Re: Review of TMAC's 2019 Annual report for Hope Bay Project.

Cambridge Bay Ikaluktutiak Dear Richard Dwyer, the KIA has reviewed TMAC's 2019 Annual Report for the Hope Bay project to the NWB.

1.3 KIA-NWB-03

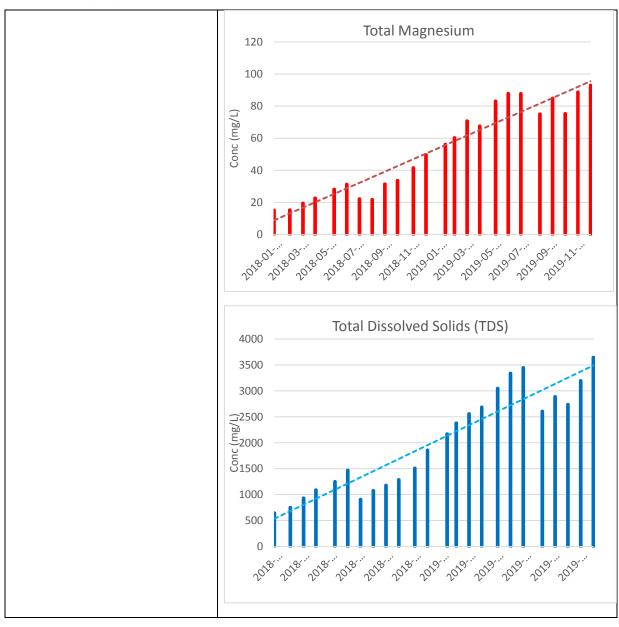
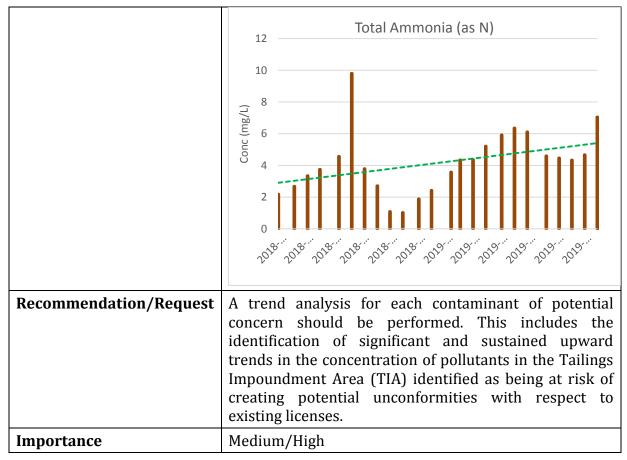
Review Comment Number	KIA-NWB-03
Subject/Topic	Water discharge from the Landfarm (ST-4).

References	HOPE BAY PROJECT 2019 Nunavut Water Board - Annual Report
Summary	"Water quality samples were collected on June 17 from the Land farm (ST-4) prior to discharge ofsecond sample was collected on June 24 and exceeded the discharge criteria for Oil & Grease and Visible Sheen." Water discharge from Landfarm presents visible oil sheen and the second sample collected on June 24 shows exceedance for Oil & Grease criteria.
Detailed Review Comment	Same as above.
Recommendation/Request	The source of Oil & Grease should be identified to prevent future contamination of the water discharged from the Landfarm sump.
Importance	Low

1.7 KIA-NWB-07

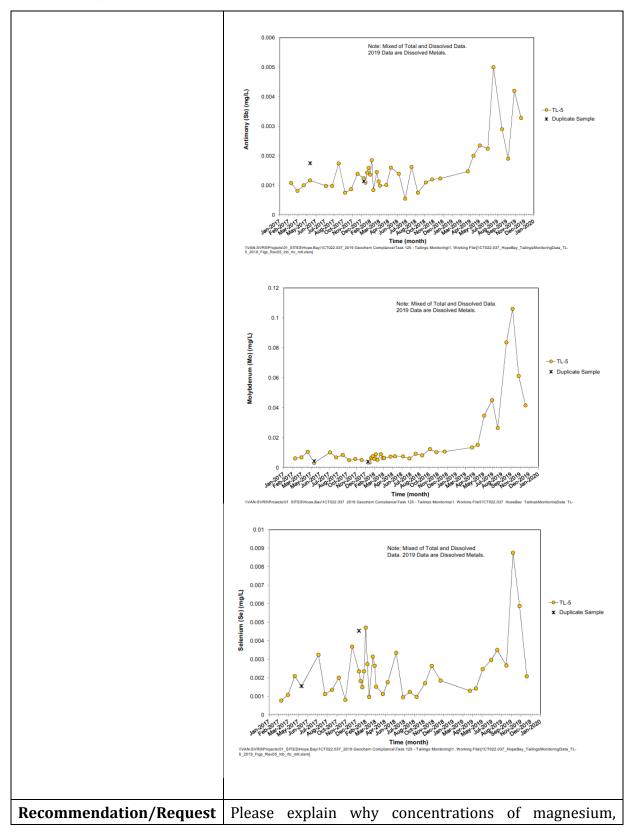
Review Comment Number	KIA-NWB-07
Subject/Topic	Increased concentrations of tailings parameters
References	Hope Bay 2019 Annual Report, 8. Geochemical Studies, 8.1.2 Tailings, 8.1.2.1 Effluent from Process Plant Tailings (TL-5), Appendix F – 2019 Waste Rock, Quarry and Tailings Monitoring Report
Summary	Several parameters showed increasing trends in the process plant tailings water discharge to the TIA in

2019, including spikes in concentrations in August or
	October.
Detailed Review Comment	TMAC states that, for effluent from process plant tailings, "trends for major ions and trace elements were stable in 2019 with ranges equivalent to 2018. Exceptions included magnesium, molybdenum, antimony and selenium, all of which exhibited increasing trends in 2019" (p. 8-4).
	It is unclear why concentrations of magnesium, molybdenum, antimony and selenium increased in 2019.
	Appendix F shows the time series of the constituent loads for the process plant tailings water discharge at TL-5 to the TIA. Many parameters show a spike in concentration in August or October 2019 compared to the rest of the year (e.g., for antimony, barium, beryllium, bismuth, cadmium, chromium, copper, lead, lithium, magnesium manganese, mercury, molybdenum, nickel, phosphorus, selenium, thallium, tin, titanium, vanadium, zinc, zirconium). This pattern for these parameters is not discussed in the Annual Report. What was the cause?

molybdenum, antimony and selenium increased in the process plant tailings in 2019.
	Please explain why many parameters exhibited a spike in concentration in August or October in the process plant tailings. We acknowledge that although the TIA did not discharge to the environment in 2019. However, ongoing increases in tailings process water concentrations may affect the ability to meet TIA discharge limits in future.
Importance	Medium
